RANDAL PARK PHASES 2–5 PLAT

SUMMARY

Updated: March 28, 2013

PRELIMINARY PLAT—PHASE 3

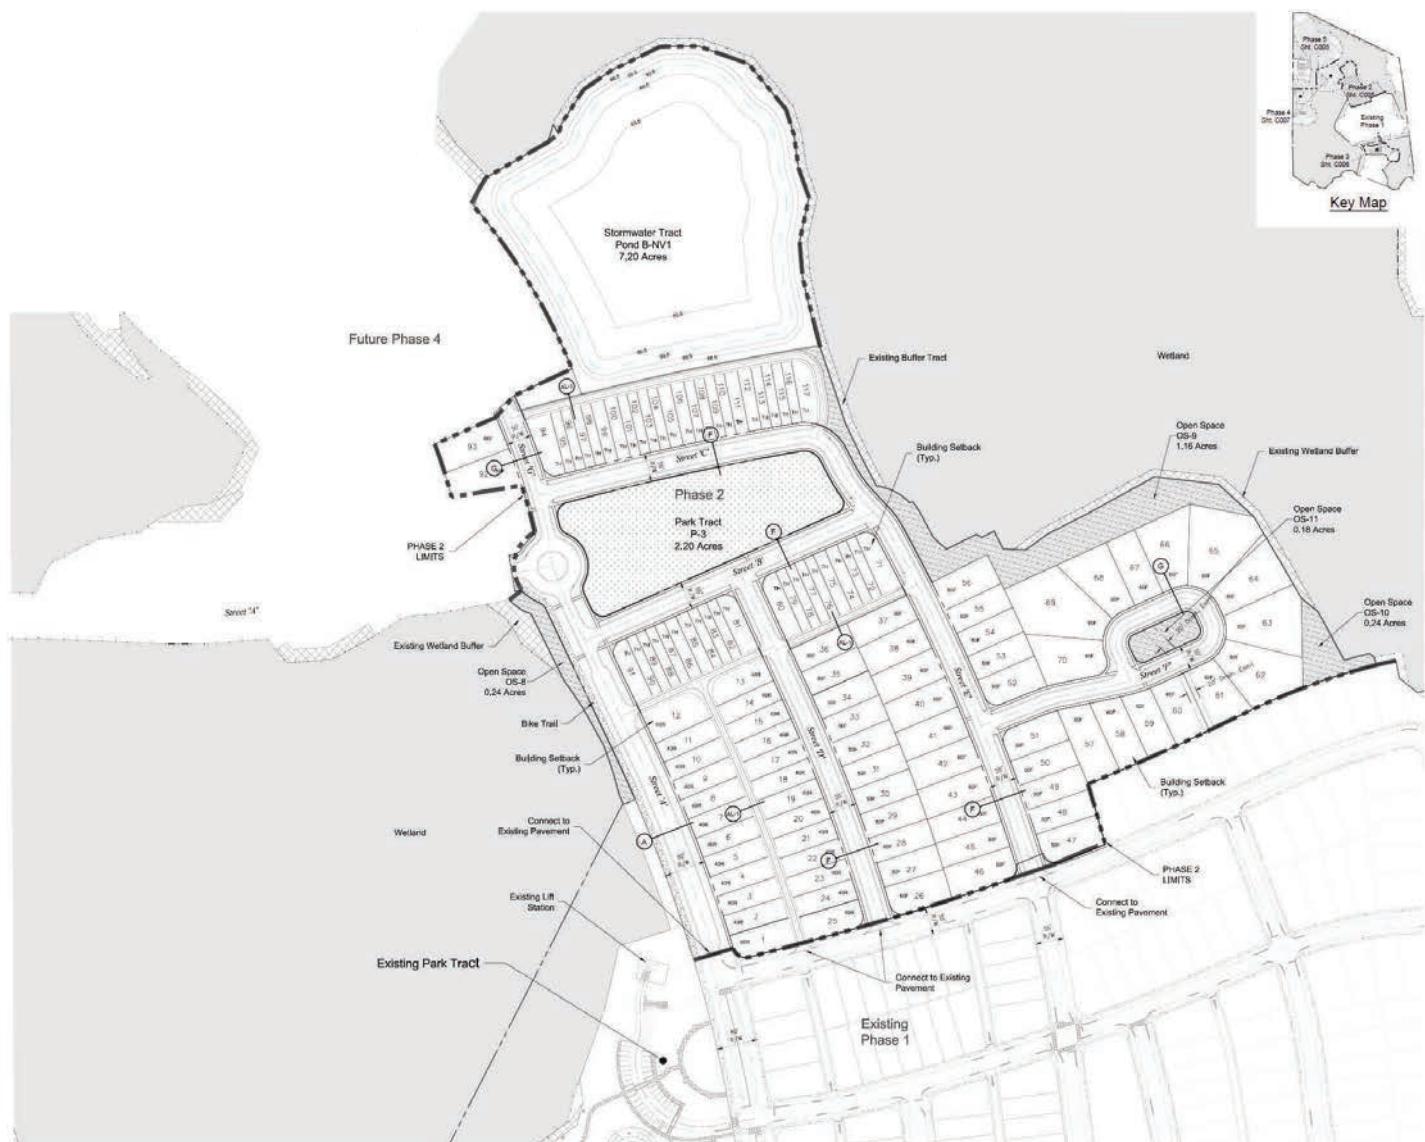
- The roadway and sewer in the southern most phase (shown as Phase 3), is under construction. Sanitary sewer main stubouts to serve Phase 3 have been installed as part of the sewer main construction to serve the school. Individual laterals will not be allowed to be cut in to the newly constructed sewer. Sanitary sewer service to Phase 3 shall be coordinated with the infrastructure currently under construction known as Randal Park Phase 3, case no. ENG2012-00937.
